SITE CHARACTERIZATION REPORT - HYDROLOGIC CHARACTERIZATION

**HYDE PARK LANDFILL SITE
TOWN OF NIAGARA, NEW YORK**

APPENDIX C - RESPONSES TO AGENCY COMMENTS

**Prepared For:
Miller Springs Remediation Management, Inc.**

figure 3-15
TRANSMISSIVITY DISTRIBUTION IN FZ-05
SITE CHARACTERIZATION REPORT
HYDE PARK LANDFILL SITE
Town of Niagara, New York

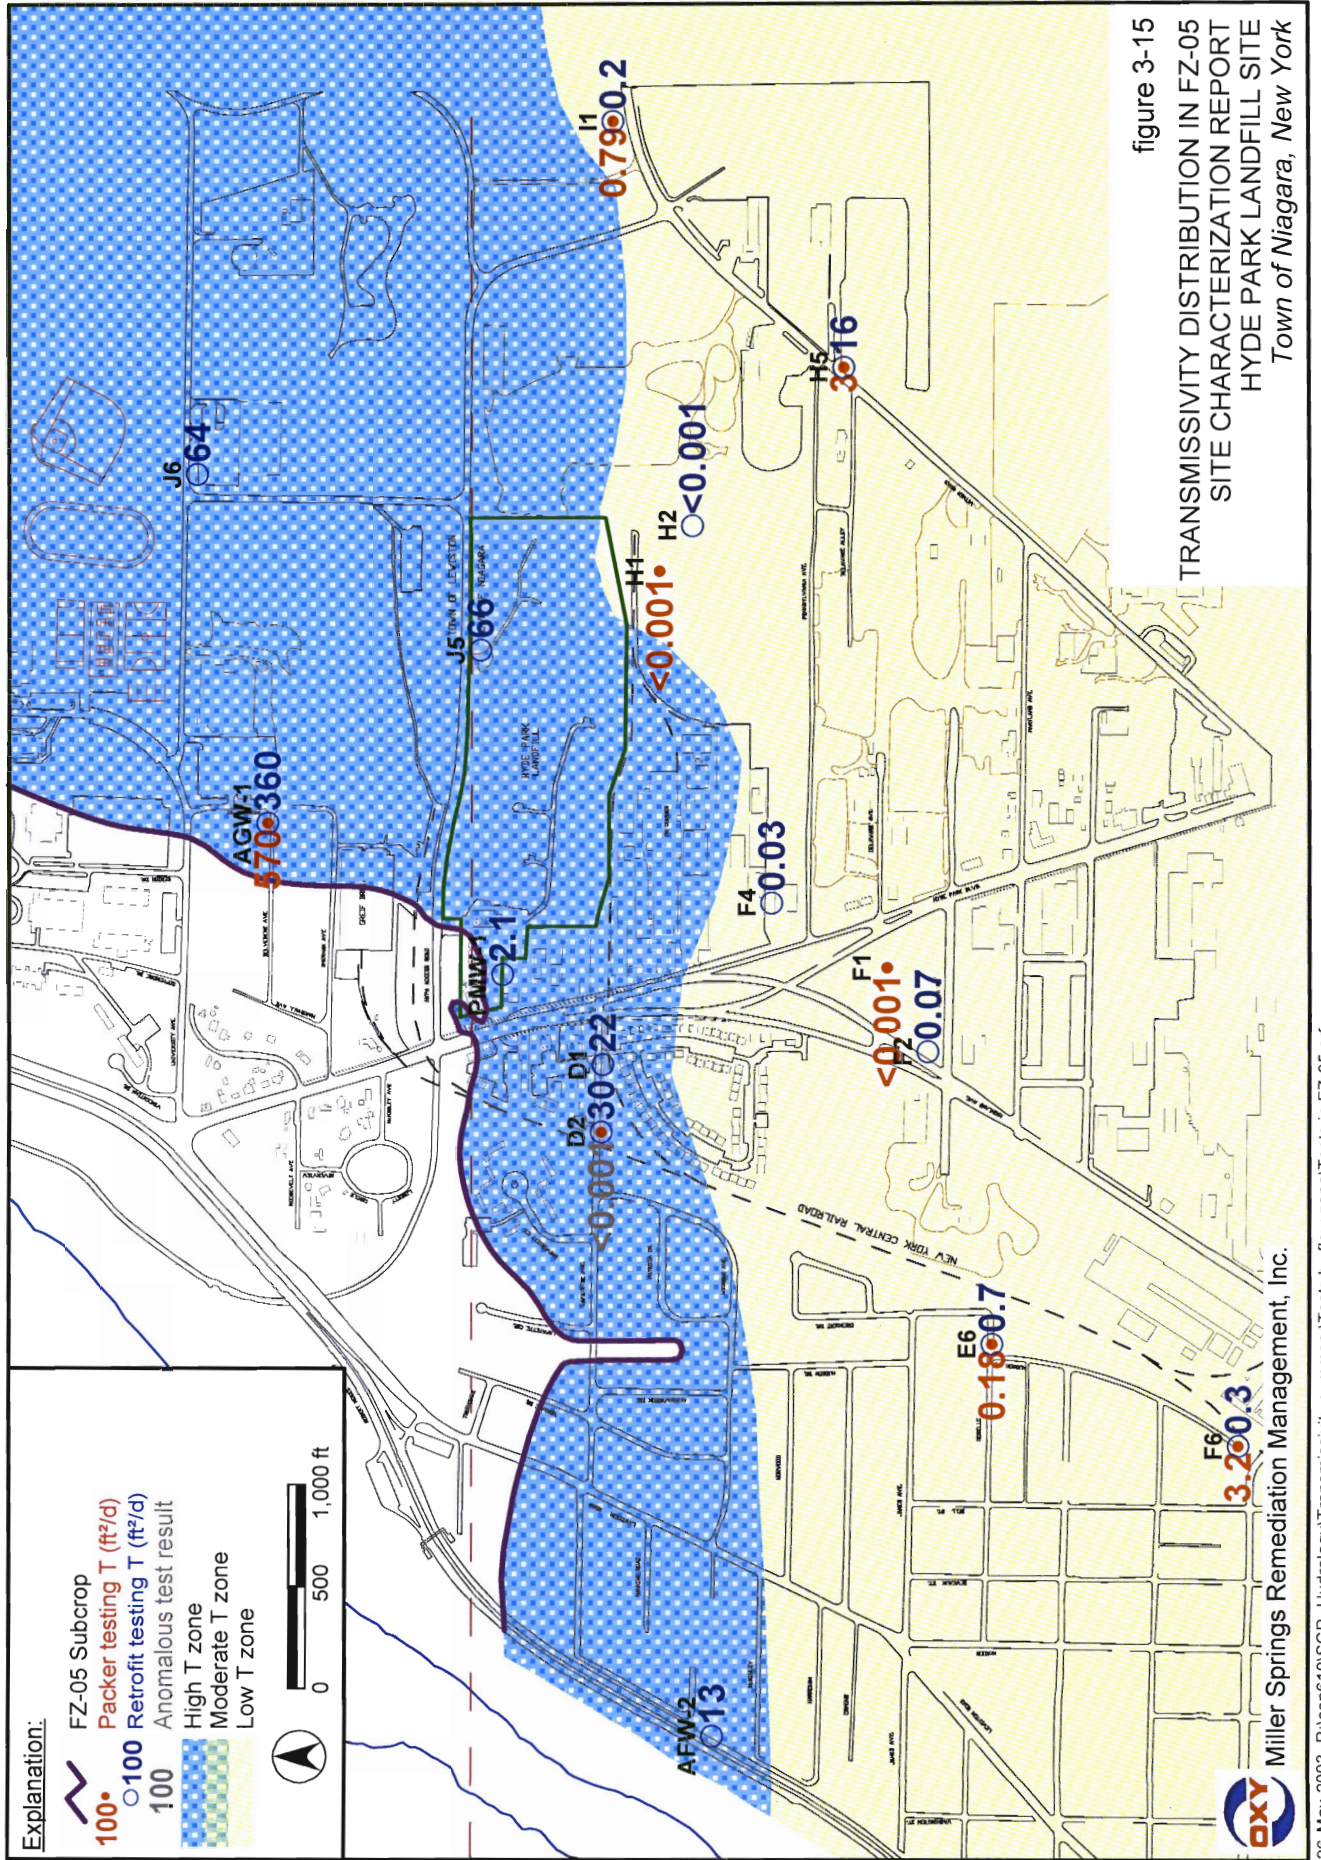
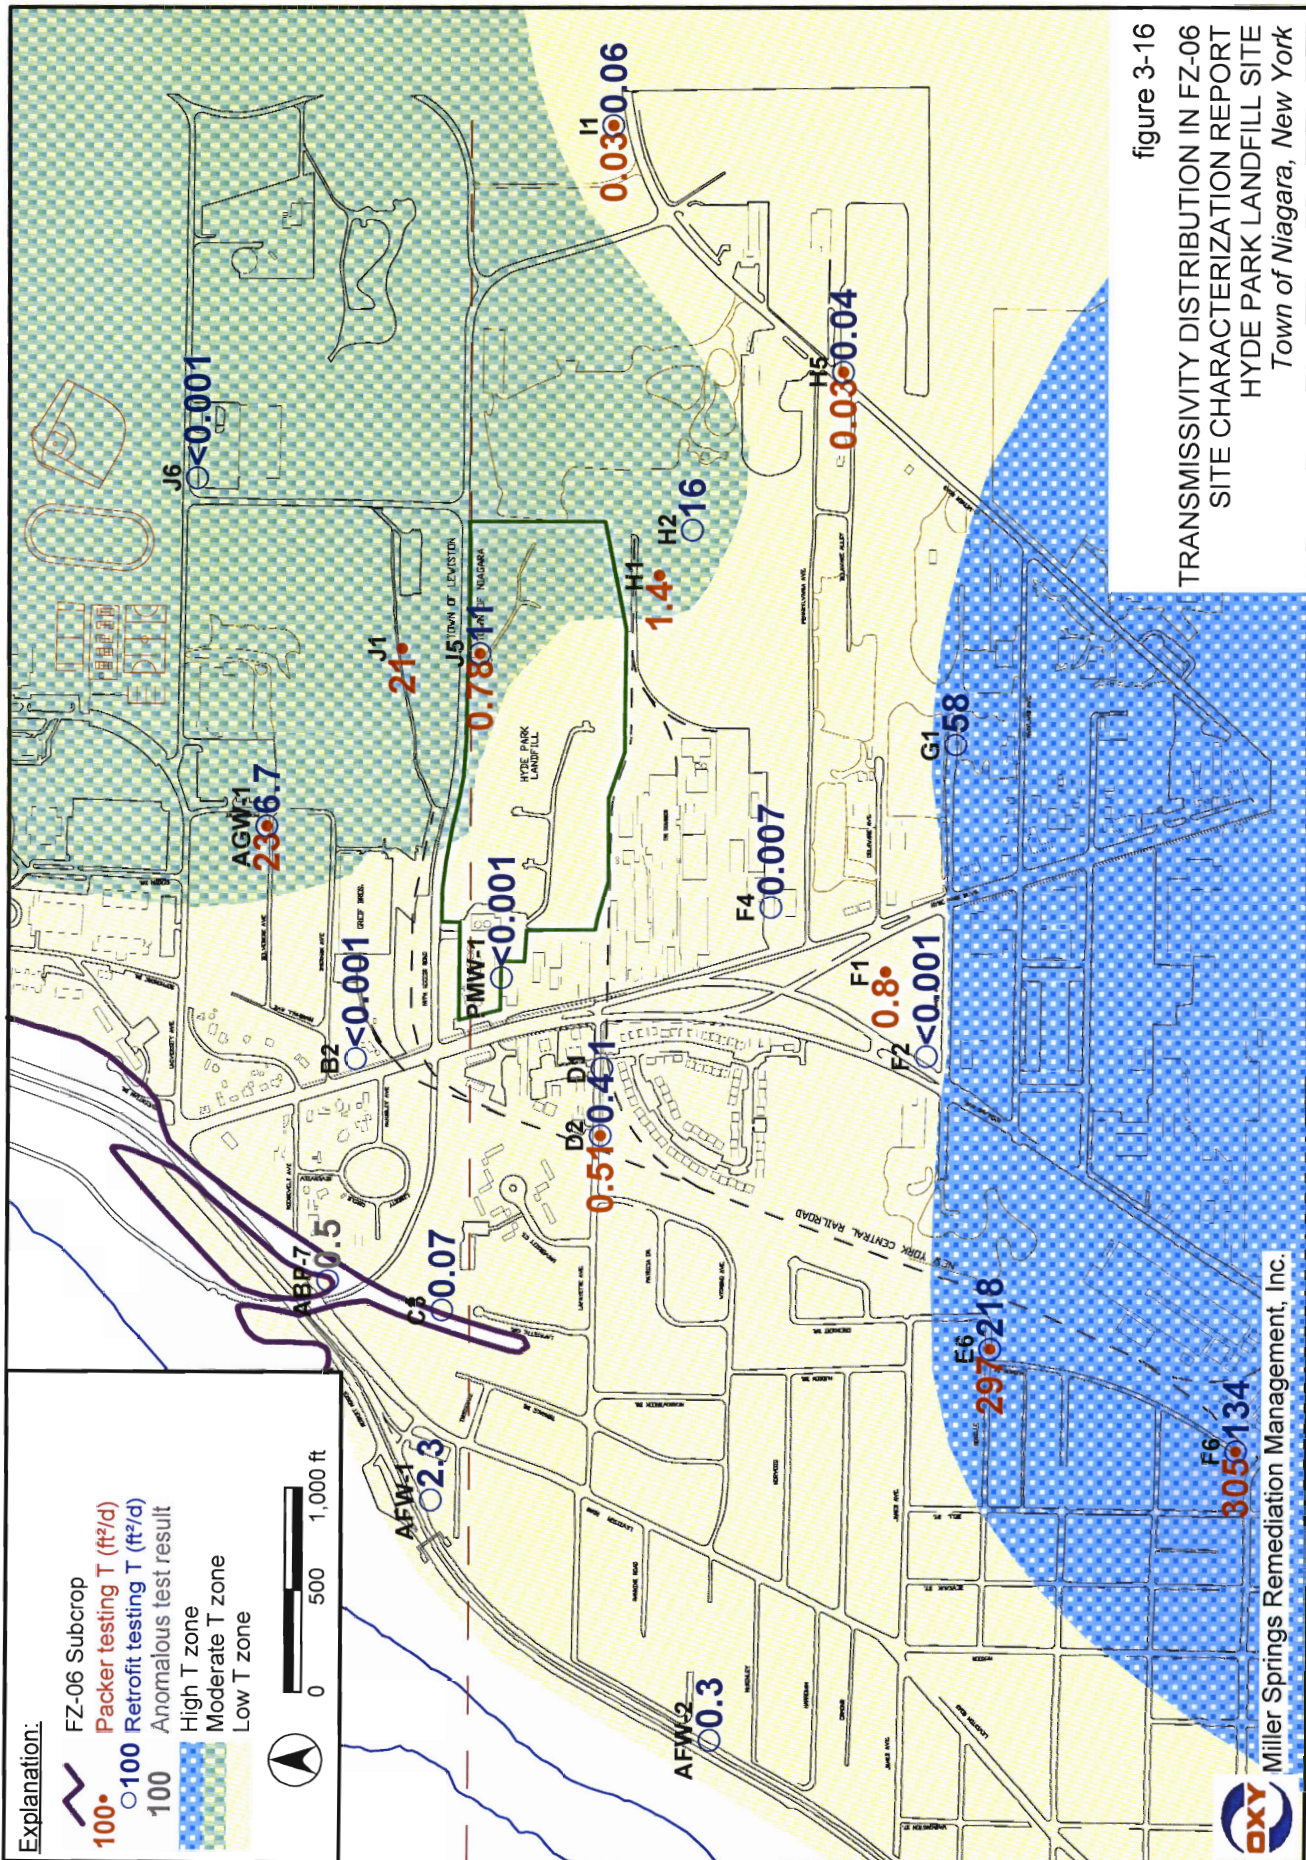
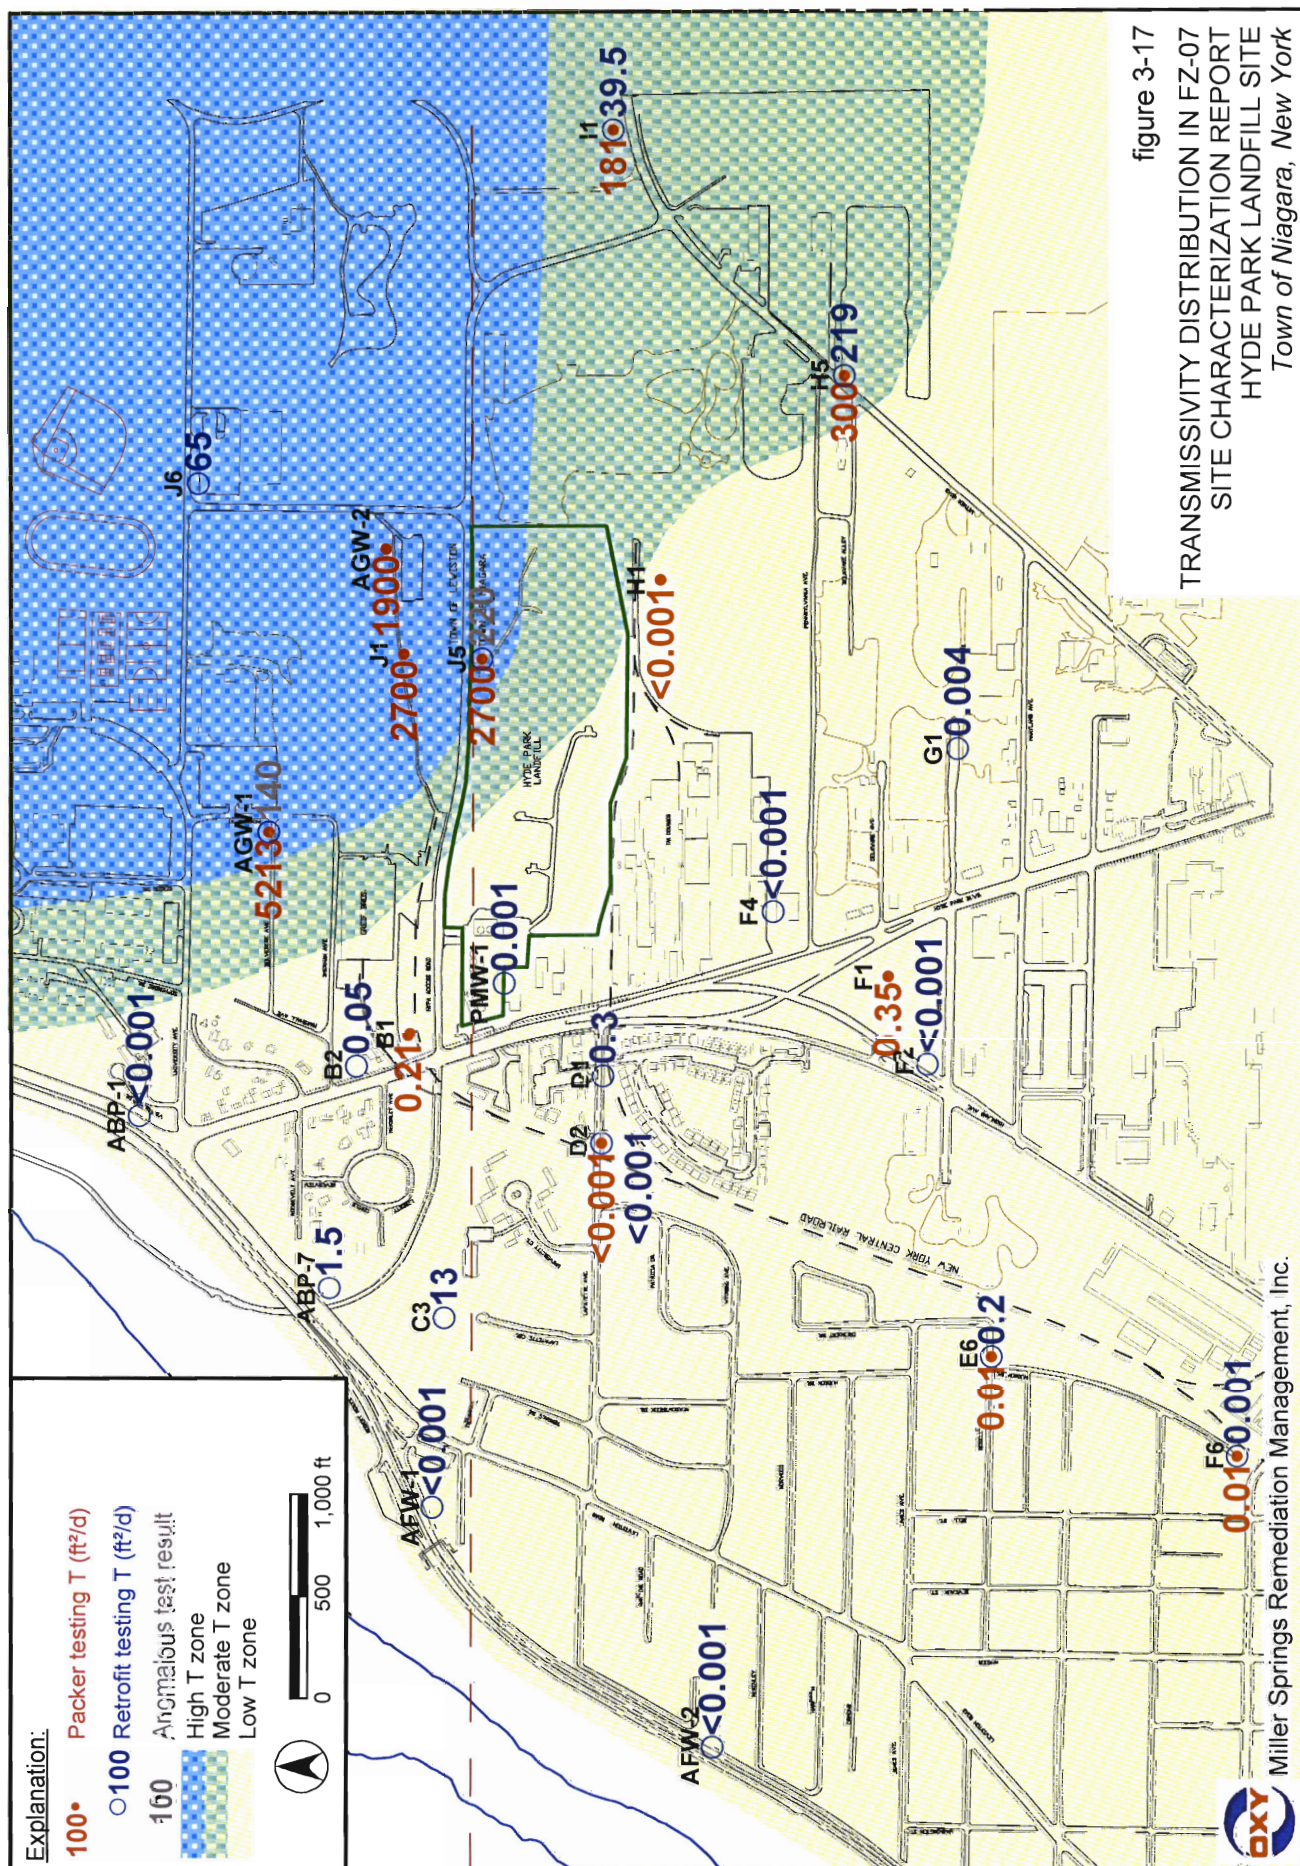
52. Figures 3-11 through 3-21. General comment: various transmissivity values are incorrect in comparison with the values presented in Appendix A. Please check values and edit.

The problem with Figure 3-12 was identified in our review of the final document. We apologize for the errors. All tables and figures have been checked. In some cases, the values indicated on the figures have been modified slightly to be absolutely consistent with the values provided in the tables. We are submitting a revised set of transmissivity maps, Figures 3-13 to 3-21, with these responses.

See the response to Comment S1.
